SEQUOYAH NUCLEAR PLANT (SQN) UNITS 1 AND 2 - NRC INSPECTION REPORT NOS. 50-327,
50-328/88-12 - UNRESOLVED ITEM (URI) 88-12-04

The referenced letter provided NRC with TVA's response to URI 88-12-04. This
URI addressed NRC's concern with the double differentiation technique used to
generate the containment design basis accident spectra.

SUPPLEMENTAL INFORMATION ON UNRESOLVED ITEM (URI) 88-12-04

Figure No. D.7
Acceleration Response Spectra
Comparison

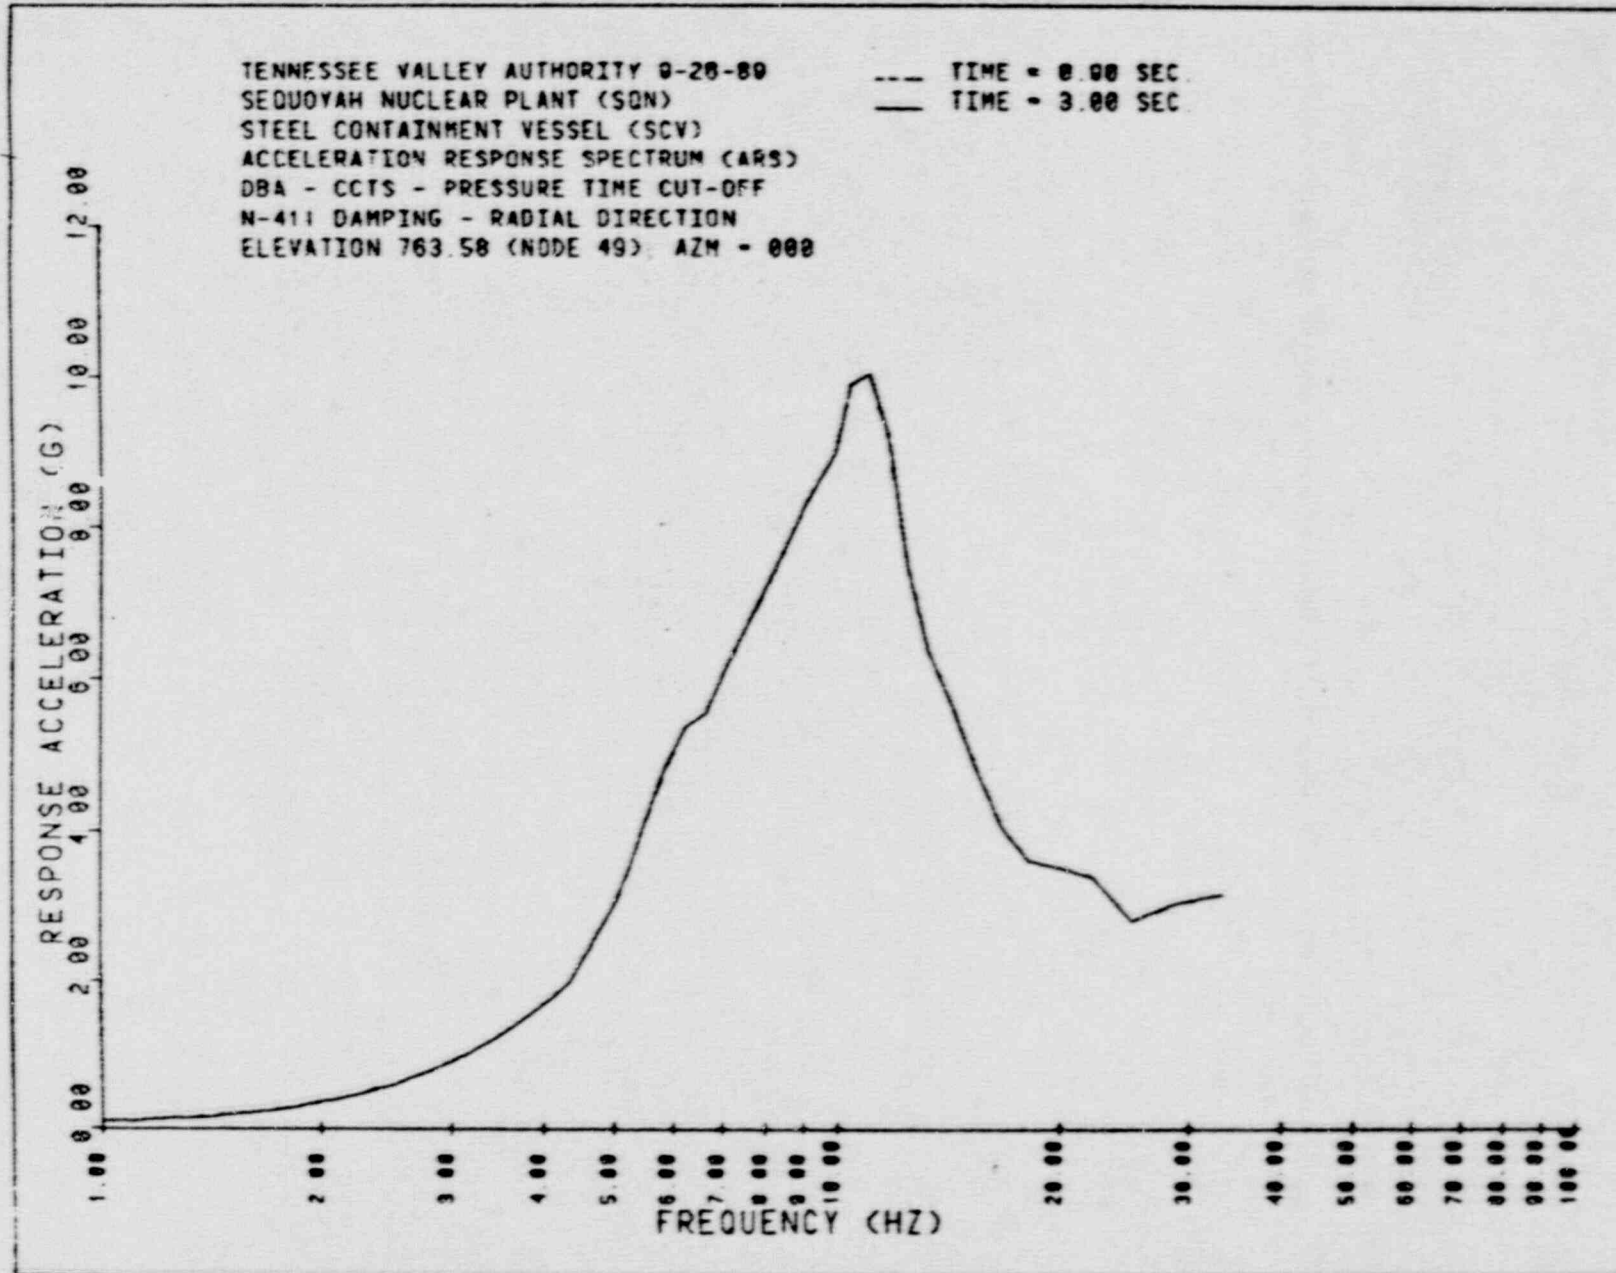
4. Item 4 will provide the calculation that has been developed to demonstrate effects on DBA spectra beyond 0.9 second to include a digitized comparison of the acceleration response spectrum (ARS) curves.

The comparison of the results from the two analyses show that the acceleration time history records are identical in the 0.0 to 0.90 seconds range and that between 0.90 second and 2.50 seconds the record decreases in amplitude. Additionally, the comparison of acceleration response spectra shows that the dynamic response of the steel containment vessel is unchanged by the addition of pressure data beyond 0.90 seconds.
